OCONEE NUCLEAR STATION, UNIT NO. 1

AMENDMENT TO FACILITY OPERATING LICENSE

Amendment No. 37
License No. DPR-38

ATTACHMENT TO LICENSE AMENDMENTS

UNIT 1
CORE PROTECTION SAFETY LIMIT
OCONEE NUCLEAR STATION
FIGURE 2.1-2A

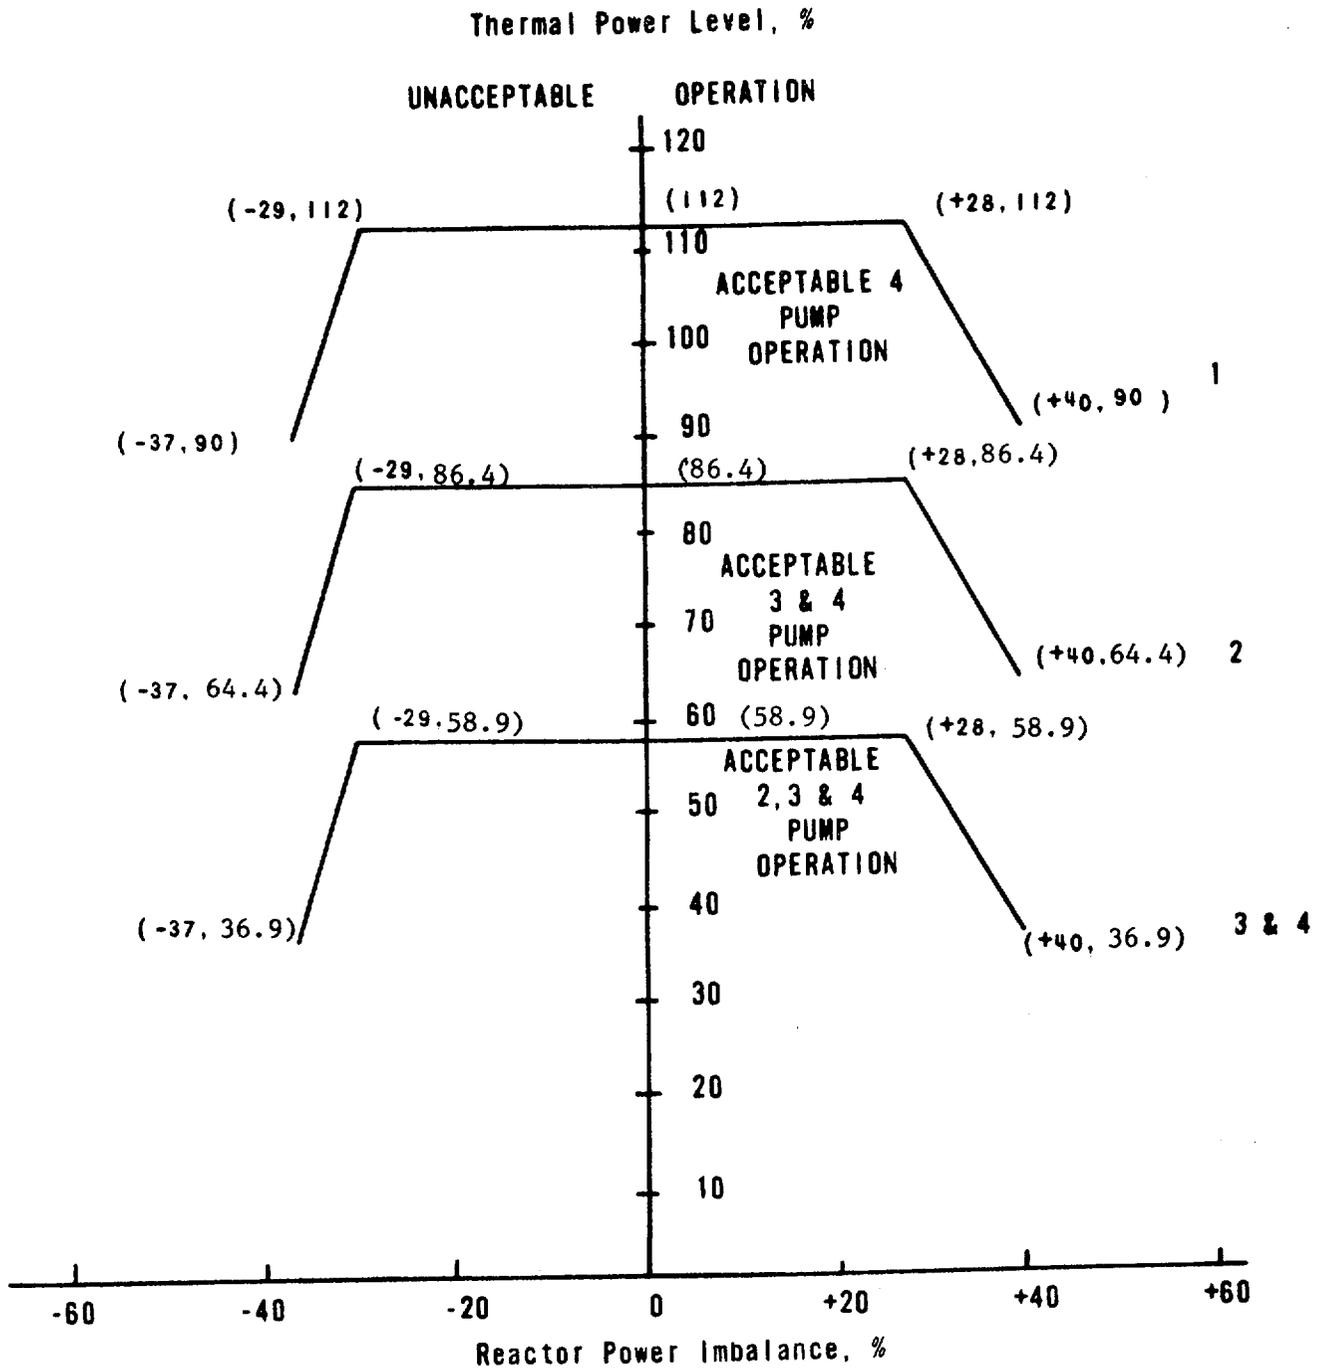
The specified flow rates for Curves 1, 2, 3 and 4 of Figure 2.1-2A correspond to the expected minimum flow rates with four pumps, three pumps, one pump in each loop and two pumps in one loop, respectively.

The maximum thermal power for three-pump operation is 86.4 percent due to a power level trip produced by the flux-flow ratio 74.7 percent flow \times 1.07 = 79.9 percent power plus the maximum calibration and instrument error. The maximum thermal power for other coolant pump conditions are produced in a similar manner.

These amendments will increase the flux/flow trip setpoint of the Reactor Protective System for Unit 1 from 1.055 to 1.07. This increase results from the elimination of the reactor internals vent valve flow penalty.

FIGURE 2.3-2A

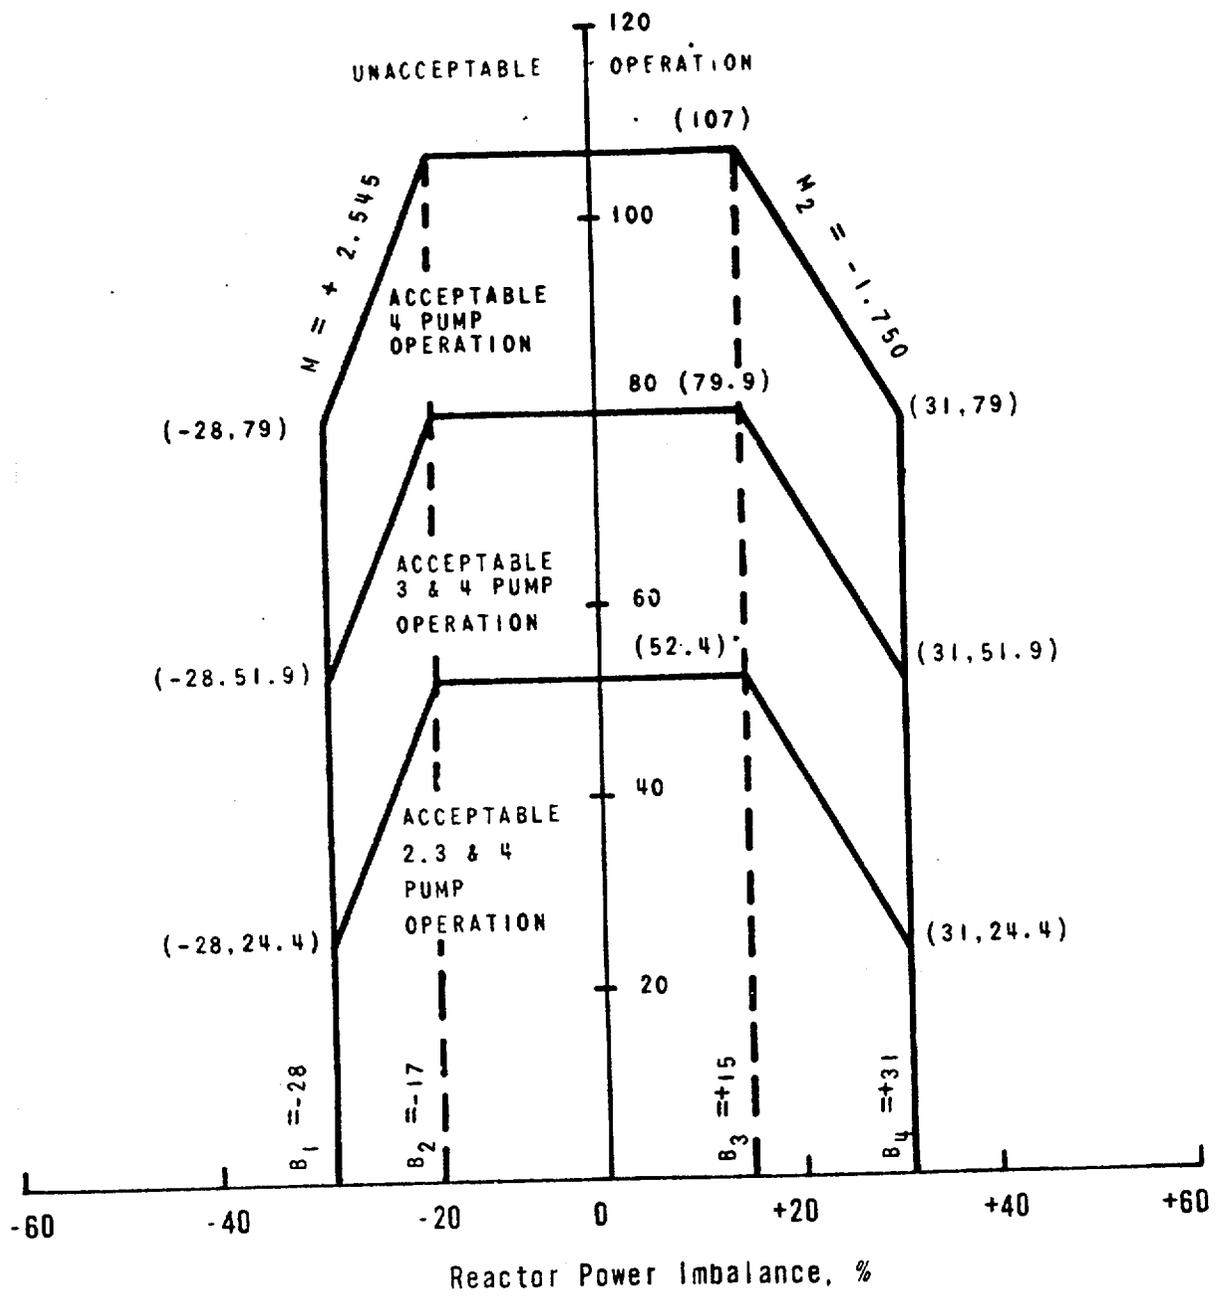
The power-imbalance boundaries are established in order to prevent reactor thermal limits from being exceeded. These thermal limits are either power peaking kw/ft limits or DNBR limits. The reactor power imbalance (power in the top half of core minus power in the bottom half of core) reduces the power level trip produced by the power-to-flow ratio such that the boundaries of Figure 2.3-2A - Unit 1 are produced. The power-to-flow ratio reduces the power

level trip and associated reactor power/reactor power-imbalance boundaries by 1.07% for a 1% flow reduction.

The power-to-flow reduction ratio is 0.961 during single loop operation.

The Technical Specifications proposed by the licensee reflect the elimination of the vent valve flow penalty by raising the flux/flow trip setpoint to 1.07 from 1.055.
